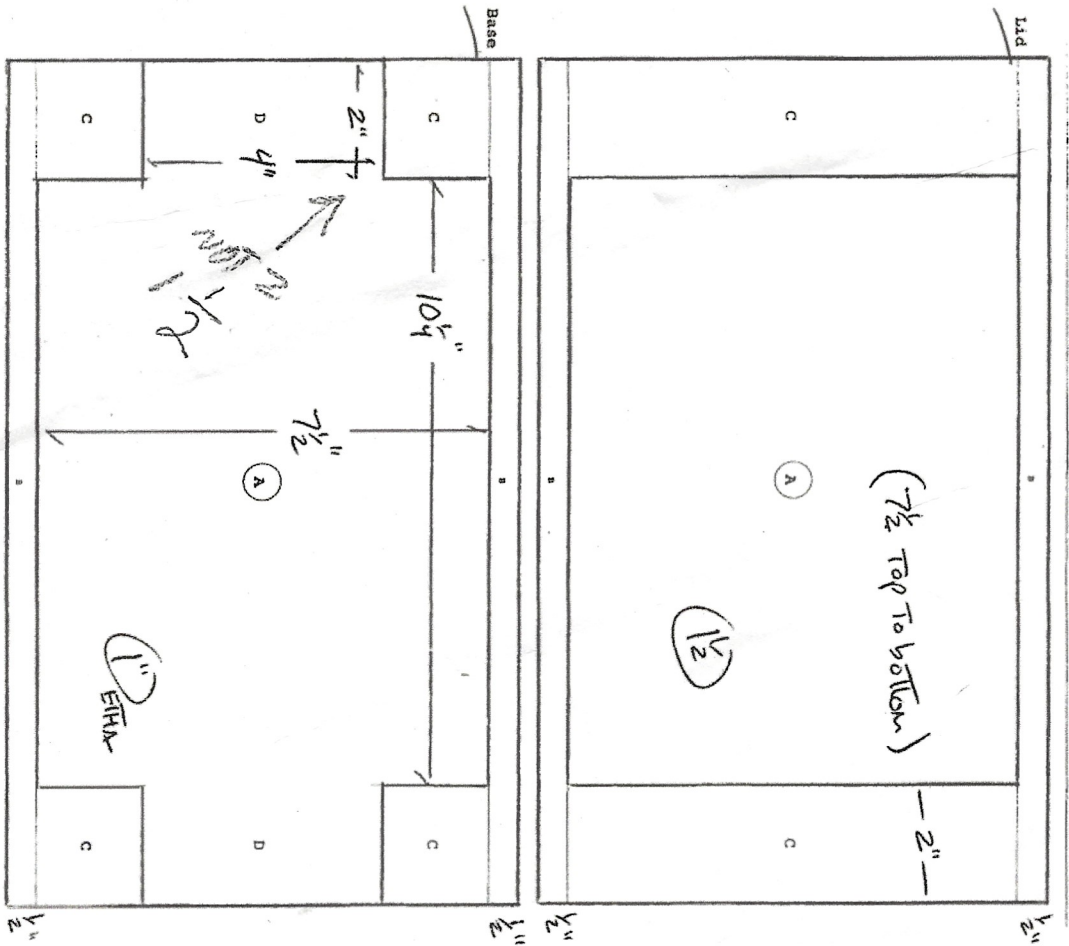
I CHANGED AREA "D" SHOULD BE

4" X 1 1/2"

THIS MAKES CORNER
DIMENSION OF TOP
& BOTTOM

13 1/4

bottom CORNERS HAVE
METAL BUMPS

INSIDE DIMS
1/4" Plywood
